COMMUNITY DEVELOPMENT DEPARTMENT REPORT

HEARING DATE: 7/17/2025
TO: Planning & Zoning Commission
FROM: Sonya Allen, Associate Planner
208-884-5533
sallen@meridiancity.org
APPLICANT: The Land Group
SUBJECT: H-2025-0012
Touchmark – MDA, PUD, RZ

Touchmark Mixed-Use
10.23.2024

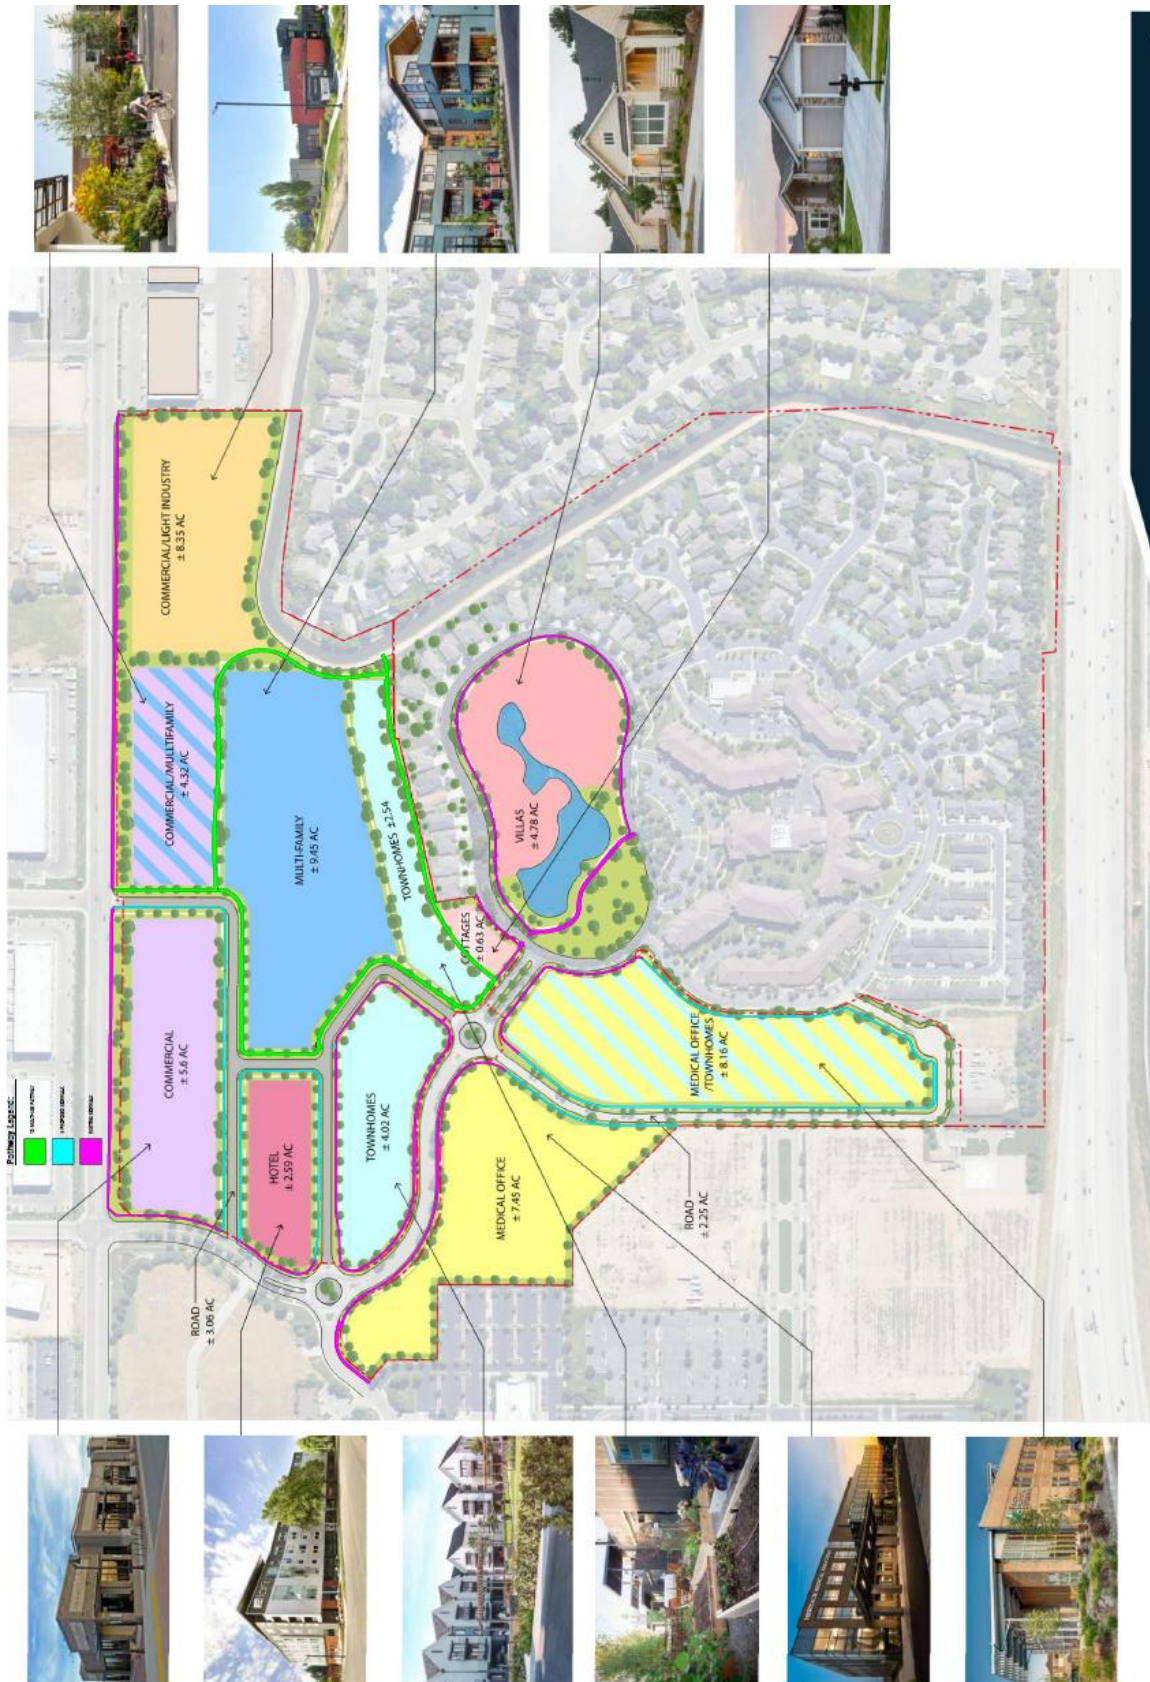
A “bubble” plan was submitted for the concept plan, which doesn't depict building locations. Staff recommends buildings are arranged to comply with this standard as a condition of the PUD.

The concept plan depicts one (1) new driveway access via E. Franklin Rd., which ACHD is requiring be a right-in/right-out, and driveway access via S. Touchmark Way, a collector street. **Either public or private named streets should be provided within the development for addressing purposes. The Applicant should coordinate with an addressing technician and the Fire Dept. on which streets should be constructed as private streets and named if public streets aren't provided.**

The concept plan shall be revised prior to the Council hearing as follows:

- i. Depict a drive/private street from the north/south drive in alignment with Truckee Ave. on the north side of Franklin to the Commercial/Light Industry designated property at the northeast corner of the site.**
- ii. In the two (2) areas where residential (i.e. multi-family and townhomes) is depicted as an alternate development option, remove residential and only depict commercial and medical office in those areas.**
- iii. Before villas can be approved to replace the small golf course in the existing development area, the Applicant must demonstrate compliance with the terms of the previously approved PUD in regard to open space with removal of the golf course. *The original PUD required a minimum of 10% of the gross land area of the PUD to be qualified open space, exclusive of required street buffers and incompatible land uses.***

G. Proposed Pedestrian Pathway Plan

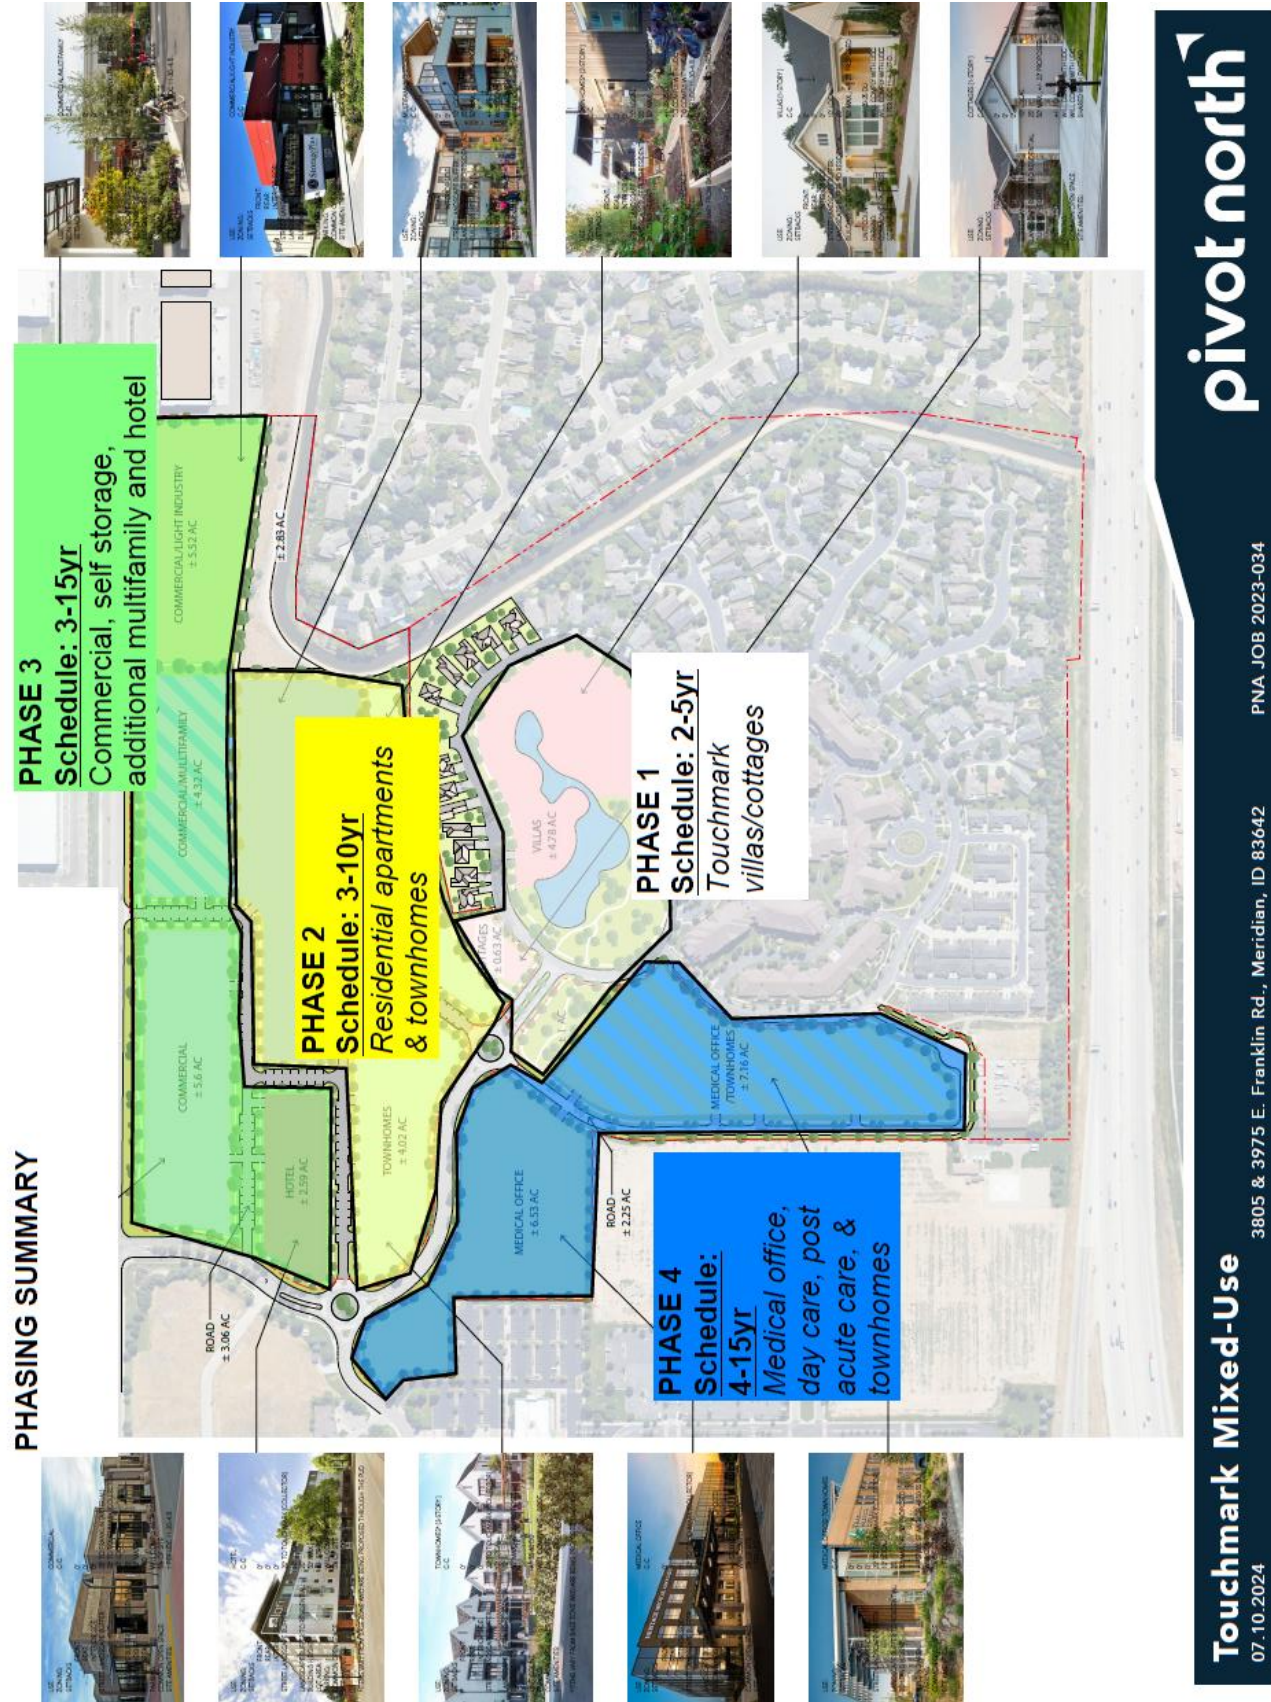
A pathway plan is proposed, included below in Section VII.G, that depicts 10' wide multi-use pathways through the site, existing sidewalks and 5' wide proposed sidewalks along streets and drives for pedestrian connectivity within the site and to adjacent properties. Private drives are proposed internally within the site for vehicular access and interconnectivity.

A pathway plan was submitted that depicts 10' wide multi-use pathways for pedestrian and bicycle access and connectivity within the development, included below in Section VII.G.

A pathway plan was submitted that depicts a 5' wide existing and proposed sidewalks for pedestrian access and connectivity within the development, included below in Section VII.G.

- iii. Pedestrian pathways and walkways are required to be provided with development in accord with the Pedestrian Pathway Plan included in Section VII.G.
